Docket Number:	09-AFC-08C
Project Title:	Genesis Solar Energy Project
TN #:	212617
Document Title:	Revised Genesis Solar Petition to Amend for Ammonia tanks and gas cylinder storage
Description:	This document supersedes and replaces TN 212350.
Filer:	Eric Veerkamp
Organization:	California Energy Commission
Submitter Role:	Commission Staff
Submission Date:	8/4/2016 10:33:40 AM
Docketed Date:	8/4/2016

Genesis Solar, LLC

Petition to Amend

Genesis Solar, LLC, as project owner, petitions the California Energy Commission (CEC or Commission) to amend the certification for the Genesis Solar, LLC facility (9-AFC-8) (Decision). This Petition to Amend, (Amendment), requests an addition of a Gas Cylinder storage area and an Ammonia Bulk Storage pad. Due to the extreme weather conditions in the Mojave Desert and the concerns regarding the equipment deterioration.

Extend Cover North

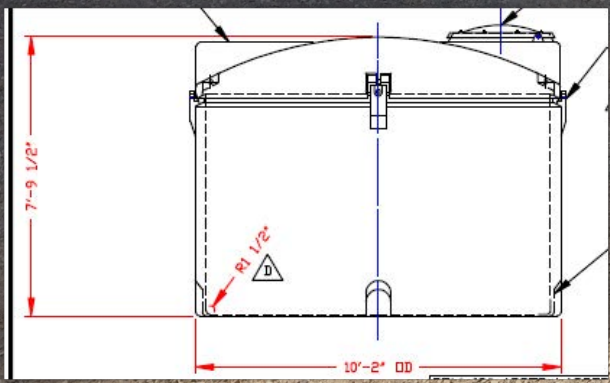
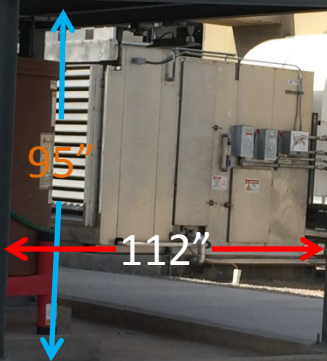
Storage area is 30x10 with 3 divider walls. Slab is 6inches thick a ground penetration will be 2 inches.

FOUNDATION & FRAMING PLAN
NEXTERA AMMONIA STORAGE TANK
GENESIS SOLAR SGN-7209
11995 Wiley's Well Road
Blythe, CA. 92225

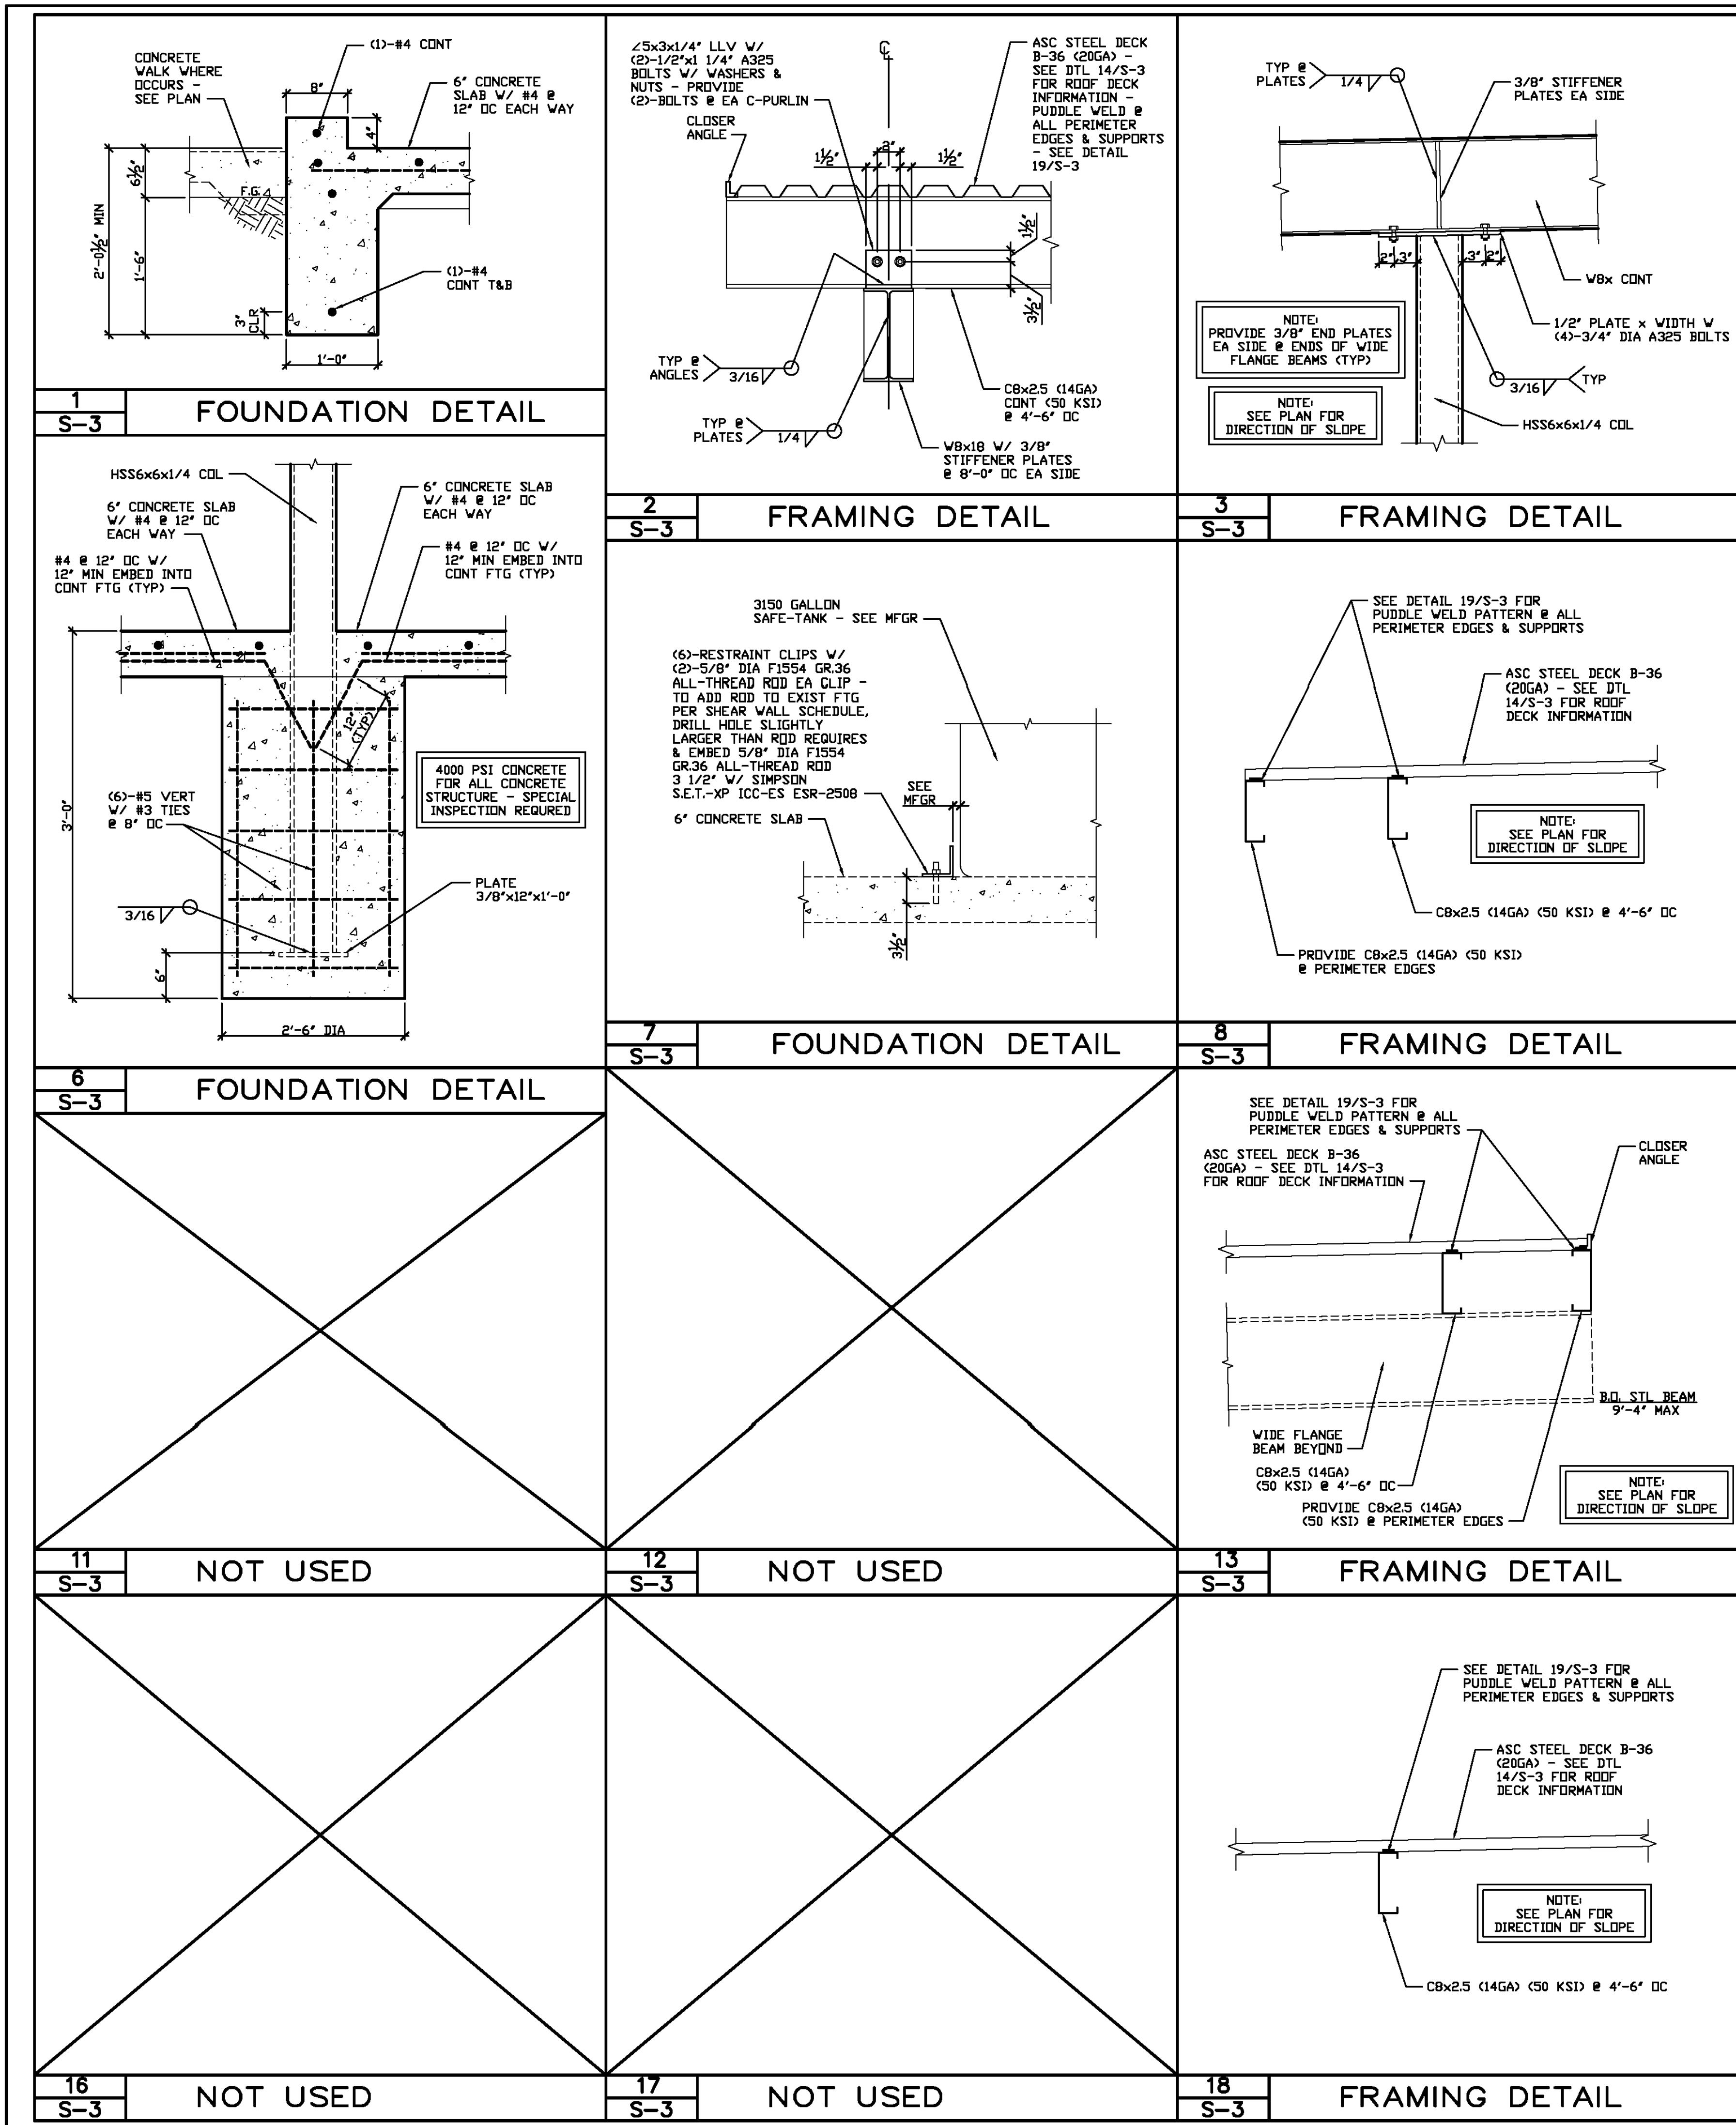
A concrete pad 13x13, 6" thick reinforced with #4 rebar on 12" centers with a 4" containment curb. and a shade cover will be installed. No additional electrical will be required. Ground penetration will be 2 inches. (See Drawings)
